## Cultural Heritage Board Certificate of Appropriateness (CR) Staff Report

I. CASE NUMBER(S): P12-0232

- 1) **Proposal:** Consideration of a Certificate of Appropriateness to approve a previously poured 450 square foot concrete slab for parking in the street side yard setback of an existing single family residence located in the Palm Heights Historic District and the R-1-7000 zone at the southwest corner of Brockton Avenue and Merrill Avenue.
- 2) **Location:** 6361 Brockton Avenue
- 3) **Applicant:** Craig Celse
- 4) **Case Planner:** Teri Delcamp, Historic Preservation Senior Planner  
(951) 826-2117  
[tdelcamp@riversideca.gov](mailto:tdelcamp@riversideca.gov)

P12-0232, Exhibit 3 - Project Plan

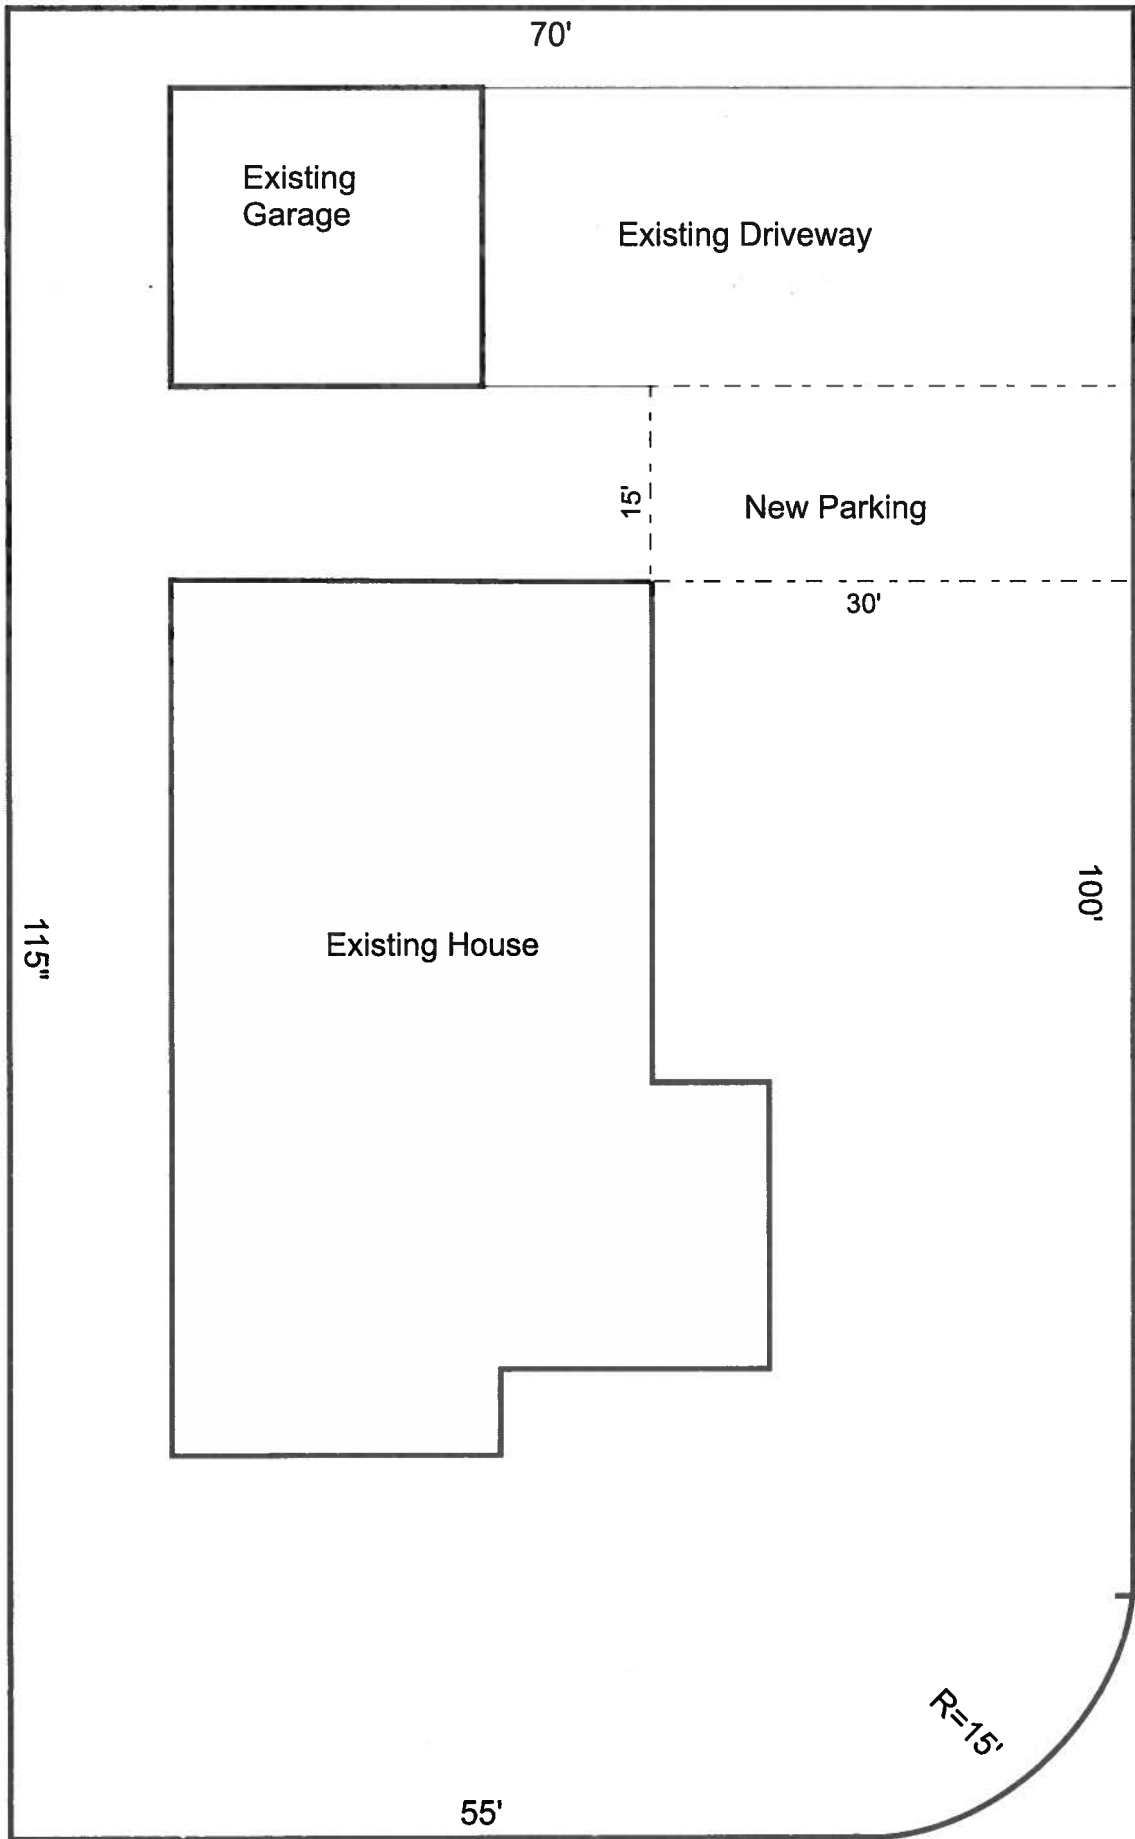
The project proposes approval of an existing concrete slab that was poured within the street side yard setback by the applicant without approval of a Certificate of Appropriateness. The slab extends to the left side of the property’s driveway, and is approximately 15’ wide by 30’ long. The applicant poured the slab in an attempt to address a Code Enforcement case regarding dead grass in the yard facing Merrill Avenue. The property has little on-street parking available since the frontages along Merrill and Brockton Avenues are red-curbed. Cars had been parked on the grass next to the driveway, killing the grass. The applicant claims that Code Enforcement discussed options with him, including the replacement of the dead grass with concrete. The applicant did not consult with Planning before proceeding with this remedy, so the Certificate of Appropriateness is being requested after-the-fact.

The PHHD Design Guidelines note that one of the character-defining features of the Historic District is its narrow driveways. Accordingly, the Guidelines call for driveways to be narrow. Several existing driveways in the District are as narrow as 10’ but are typically 12’ wide. The Guidelines also state that side yards “should not be covered with paving...to turn the...side yard into additional parking.” The property already had what appears to be a 1½ car garage with a 15’ wide driveway approach, which is already wider than the majority of residential driveways along Merrill (the attached site plan implies that the existing driveway was 20’ wide, but it is only about 15’ wide). The additional 15’ wide concrete slab expands the driveway to twice the existing driveway width and is not consistent with the PHHD Design Guidelines.

The project does not meet any of the above requirements. The expansion of the existing driveway with a 450 square foot concrete slab within the landscape street side yard setback does not comply with Section 19.580.050.I of Title 19. Concrete was poured on the opposite side of the driveway within the street side yard and does not comply with Sections 19.580.070.A.2 and 19.580.070.A.3 of Title 19.

1. Prior to commencement of work, the applicant shall revise the project and submit plans for the approval of CHB staff to show:
  - a. The proposed picket fence modified to be six feet in height, of solid wood or a combination of stuccoed masonry and wood, consistent with the architectural style and materials of the historic home.
  - b. The species, size and number of plants within the planter, proposed groundcover and method of irrigation.
2. The applicant shall complete the approved modifications within 60 days after the date of this approval.
